**RE: Adagio Apartments  
Tr A, Cantata at the Trails Unit 2  
Conceptual Grading Plan Stamp Date: 8/16//19  
Drainage Report Stamp Date: 8/16/19  
Hydrology File: C09D014**

**CITY OF ALBUQUERQUE**  
Comments from  
Planning Department  
Conceptual Grading, Drainage, & Utility Plan  
Adagio Apartments  
Tract A, Cantana at the Trails Unit 2  
Prepared By  
RESPEC, Dated August 2019

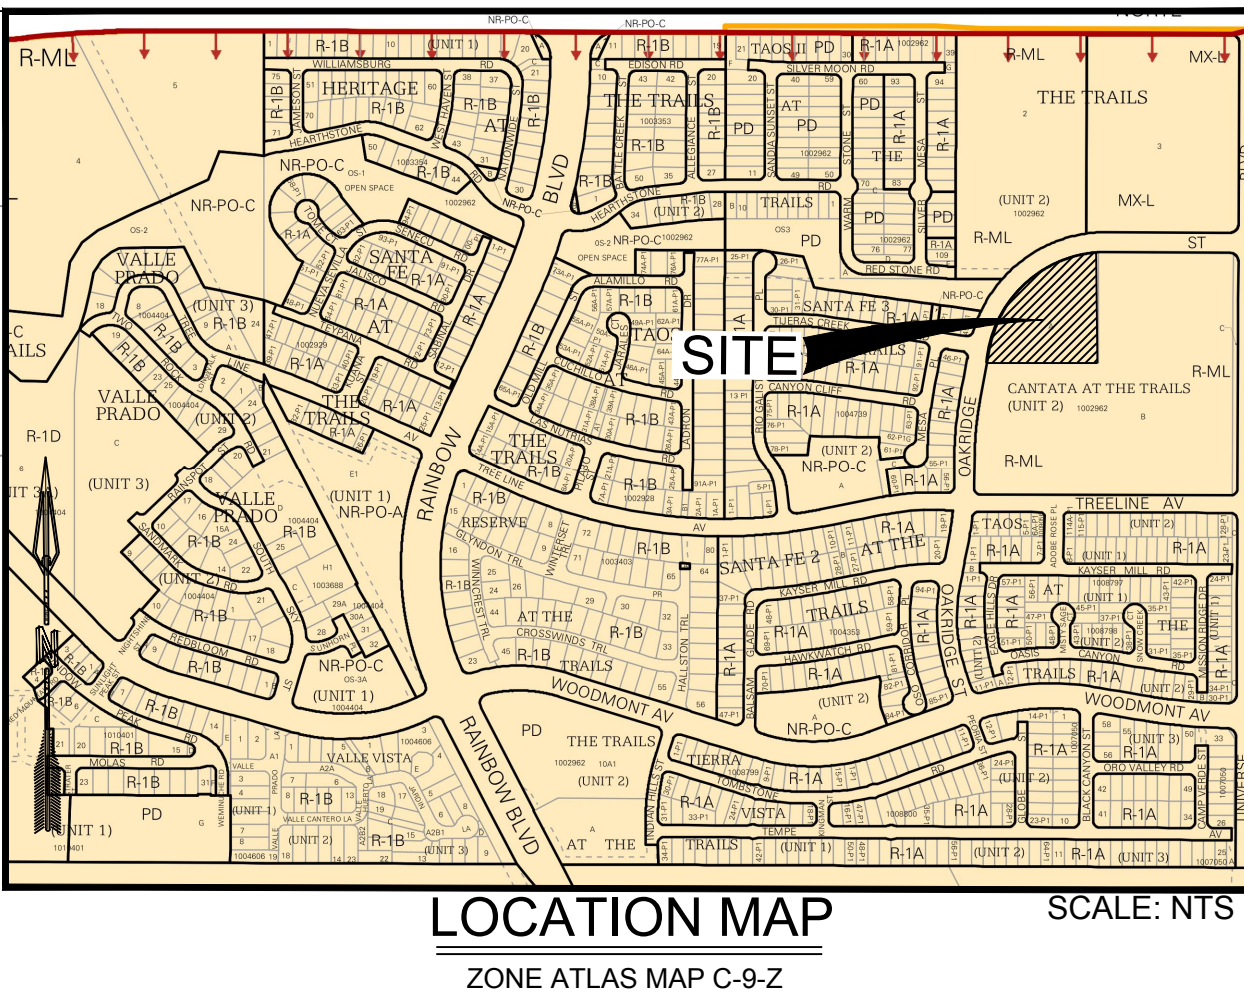
4. Include project benchmark and datum.

6. Please provide a vicinity map showing the location of the site. Typically this is the Zone Atlas. This can be downloaded in pdf format from the City of Albuquerque's website.

*Project benchmark and datum included. See revised sheet C-101.*

*A vicinity map showing the location of the site has been included. See revised sheet C-101.*

SHEET NUMBER:	<b>C-102</b>	
SUBMITTED FOR:	DRB SITE PLAN	
SHEET TITLE:	<b>CONCEPT DRAINAGE PLAN</b>	
PROJECT NAME:	<b>ADAGIO APARTMENTS</b>

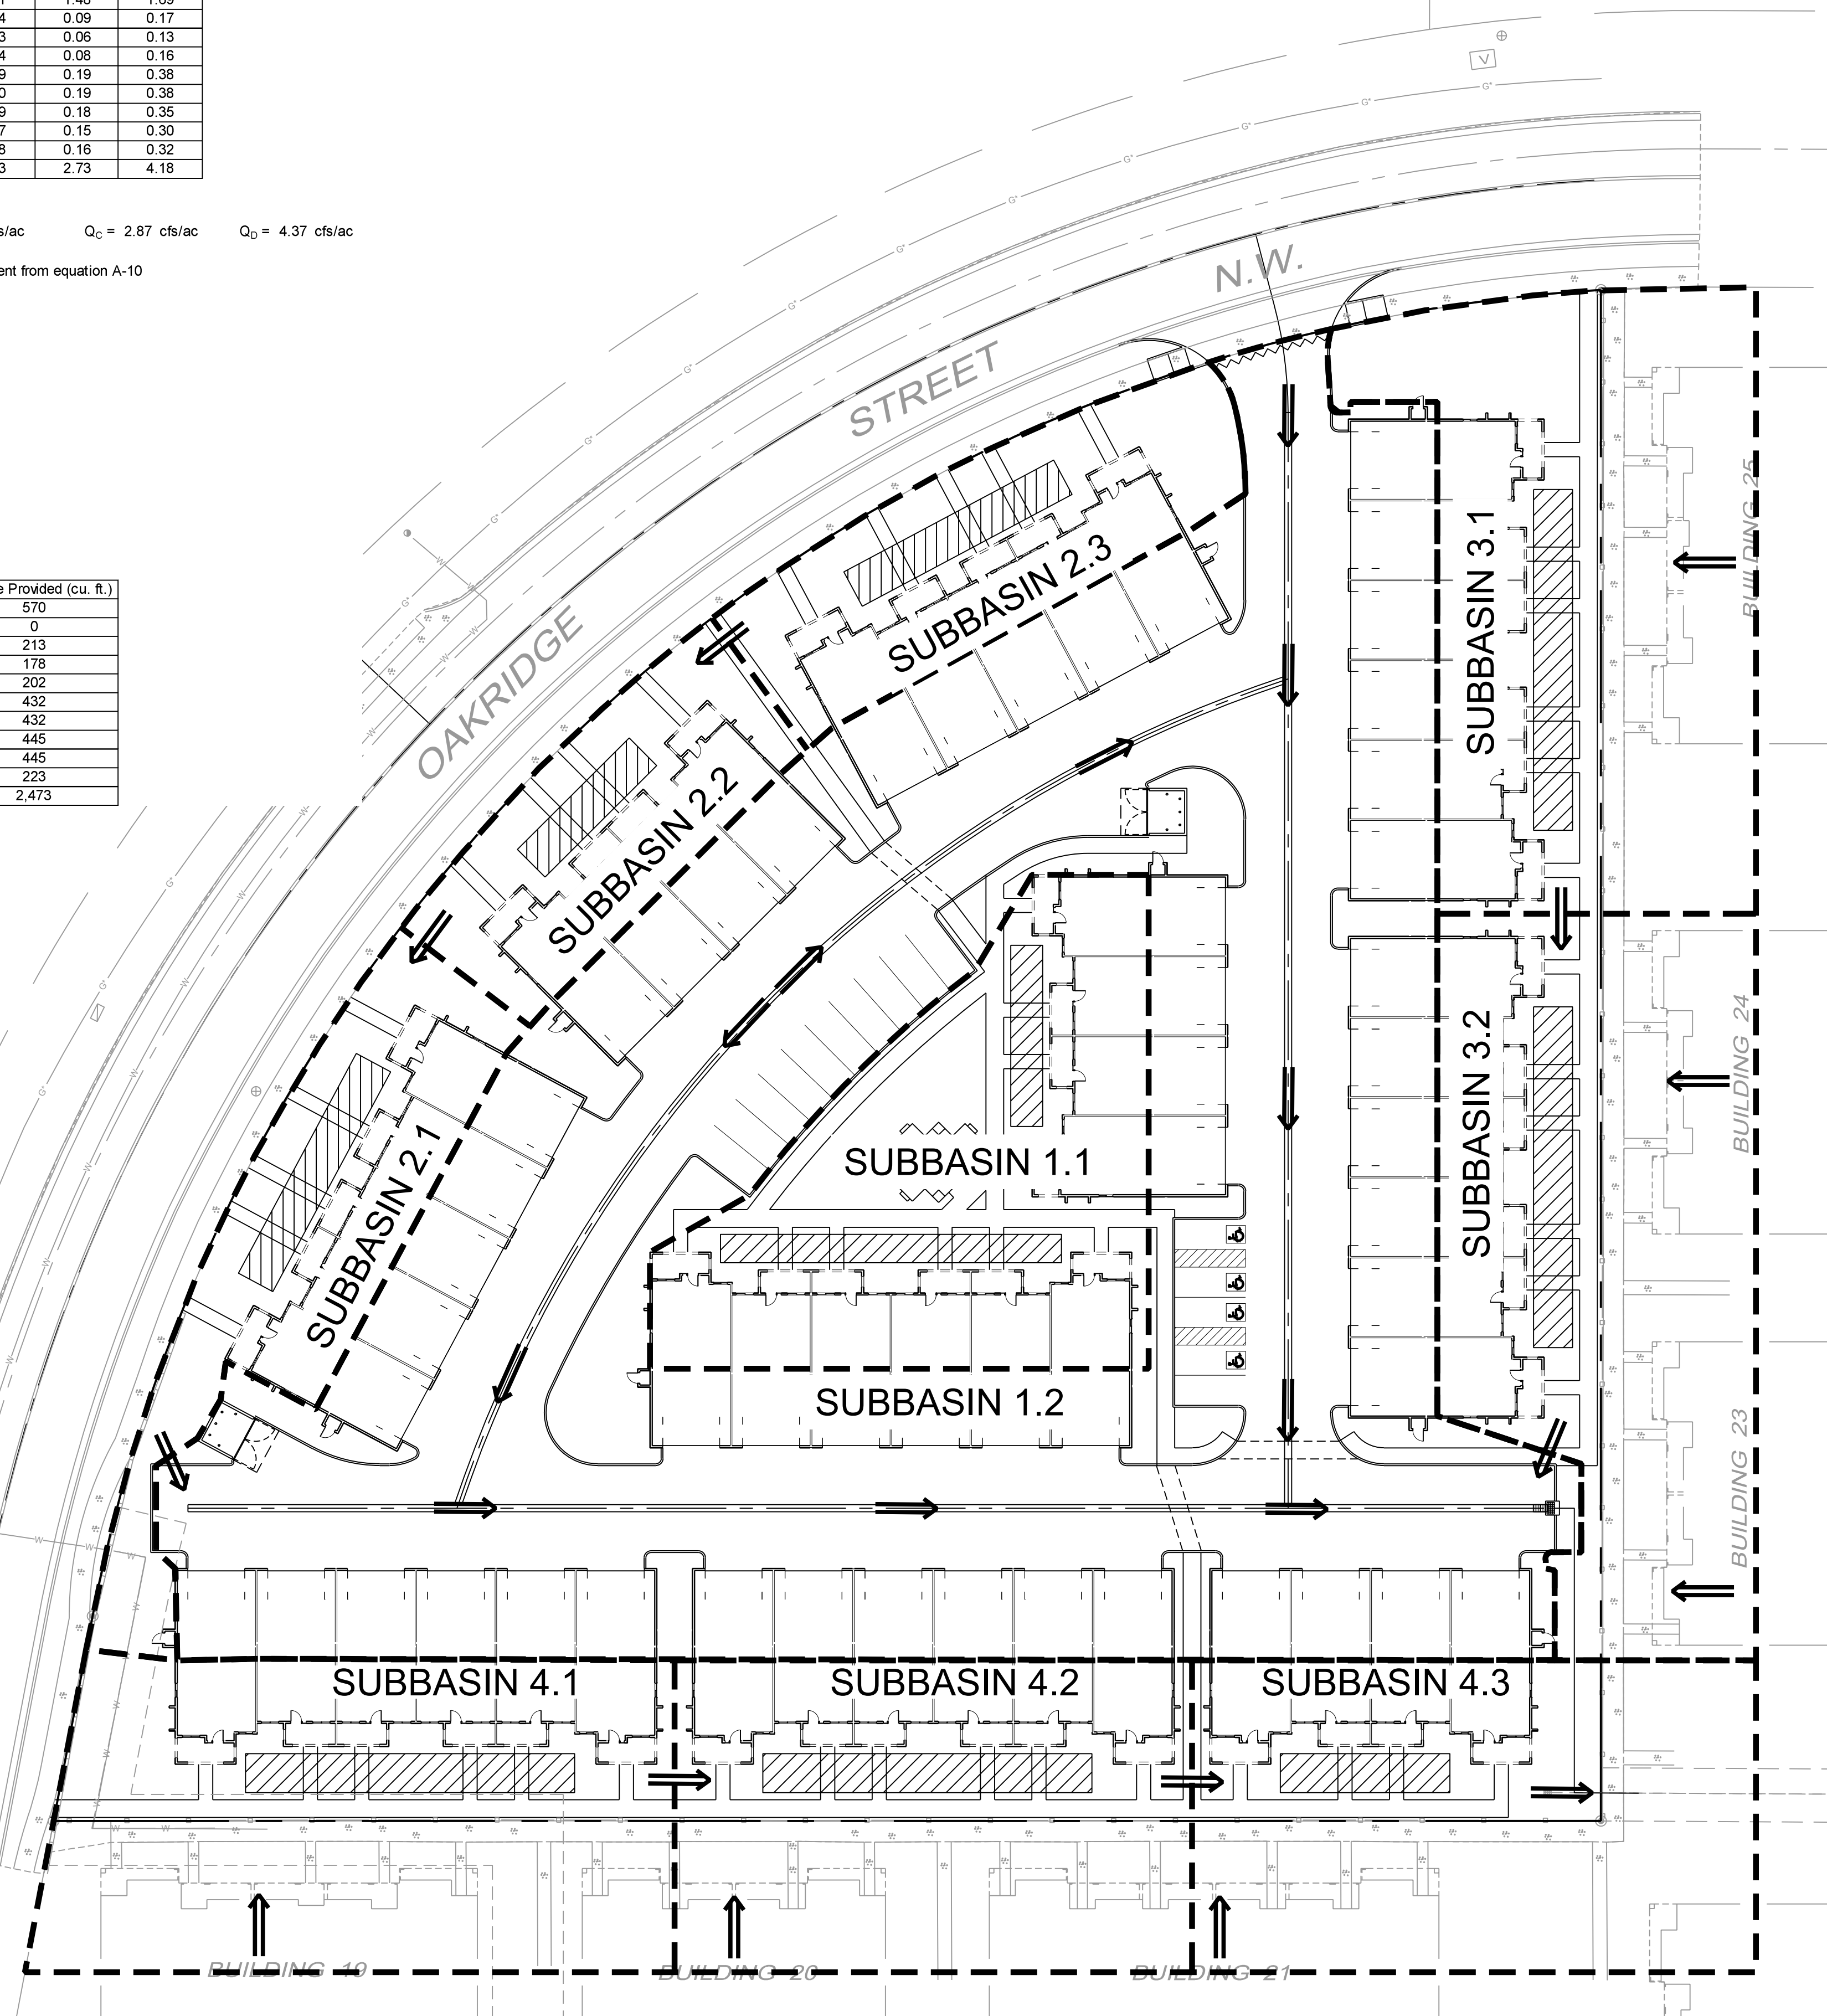
1. Remove all "Conceptual" markings.
2. Required SWQV needs to be calculated for the impervious area only. It looks like you multiplied .34/12" by the entire basin areas.

3. Payment in Lieu (Amount =  $1,827\text{CF} \times \$8/\text{CF} = \$14,613$ , per sheet C-102- Basin1.2) of onsite management of the SWQV must be made. Take three copies of the treasury deposit slip to the Treasury and then include one copy of the paid deposit slip when resubmitting.

9. Please provide the SWQV calculations for each basin draining to each pond. The stormwater quality ponds need to be sized for the areas draining to them.

13. Drainage conveyance for basins 2-4 is questionable. Will these basins actually make it to the drive aisles? If so how? Can you add low points or drain lines for the sidewalks, along with swales? You could also treat these areas as contiguous self-ponding areas, coupled with drainage covenants. This would also enable basin 1 to free discharge.

*SWQV calculations for each basin draining to each pond have been provided. See revised sheet C-102.*

*Additional flow arrows have been added to revised sheet C-102 to provide clarity on drainage conveyance.*
